To	Senior Environment and Sustainability Manager
From	Environmental Advisor, Western Distributor Smart Motorway
Priority	ROUTINE
Date	09/08/2024
Subject	Addendum assessment and decision No.9 for proposed modifications to M1 Western Distributor Smart Motorway Project

Modification to the M1 Western Distributor Smart Motorway Review of Environment Factors (REF).

Figure 4 - Technical drawing of cable tray connection detail

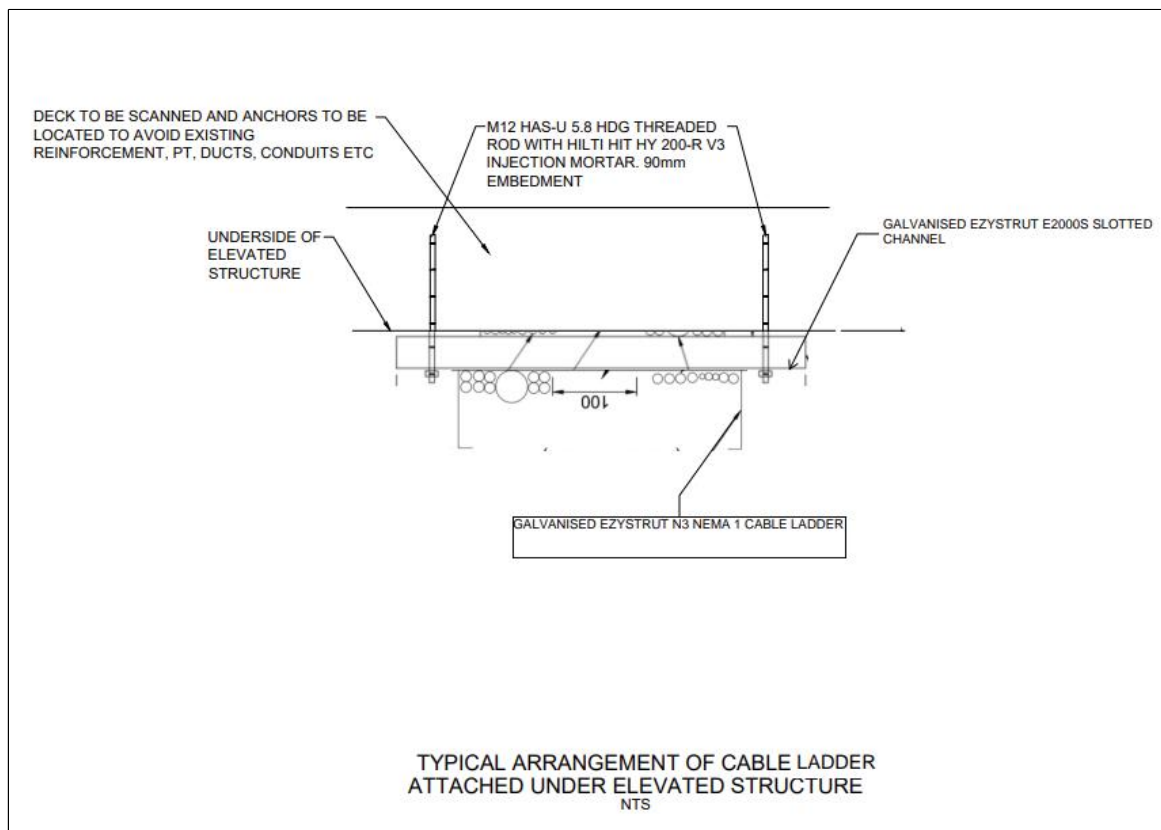
It is proposed to utilise existing conduits. Site investigations indicate that there is the necessary unused capacity in the conduits. However, if during installation this is found to not be the case new cable tray would be attached to existing Sydney Harbour Bridge structure between the existing cable tray along the underside of the wing of the Bridge as shown in Figure 3, Figure 5 and Figure 6.

Figure 7 - Conduit installation route in existing channels of the Sydney Harbour Bridge

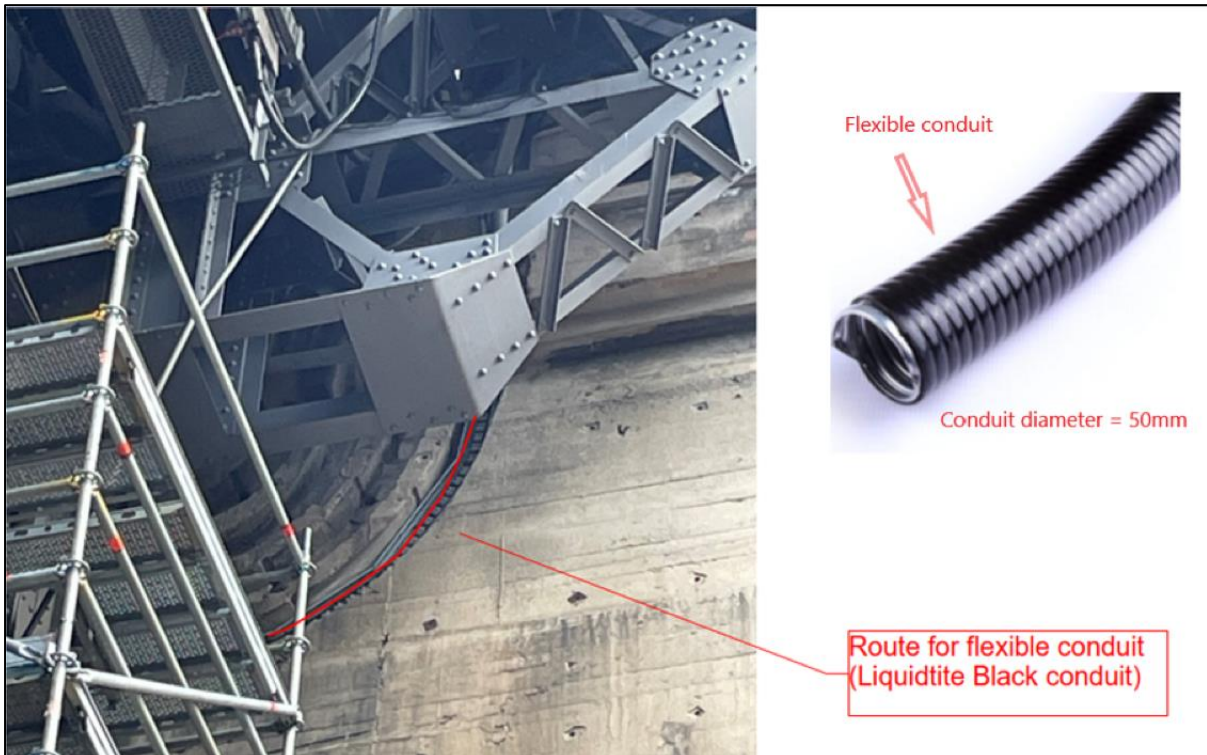
It is proposed to utilise existing conduits that run beneath the bridge. Site investigations indicate that there is the necessary spare capacity in the conduits. However, if during installation this is found to not be the case 50mm black flexible conduit would be attached using cable ties to the existing cable tray in the abutment channels as shown in Figure 7.

Figure 8 - Indicative markup of traffic management device installation on existing Sydney Harbour Bridge gantries

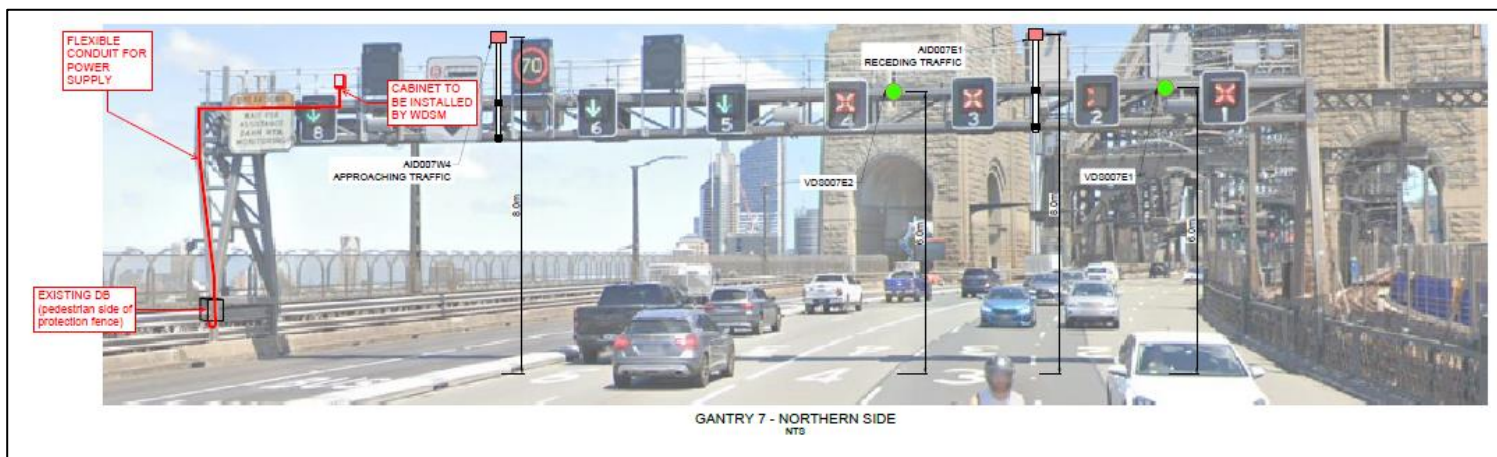
- Gantry 0
 - Gantry 1
 - Gantry 2
 - Gantry 3
 - Gantry 4
 - Gantry 6
 - Gantry 7
 - Gantry 8
 - Gantry 9
- AID and VDS will be mounted on new vertical members (to be installed by WDSM) to the top of the gantries. The structural mounts and brackets to be painted in SHB grey (excluding the devices and cabinets). See Figure 8.
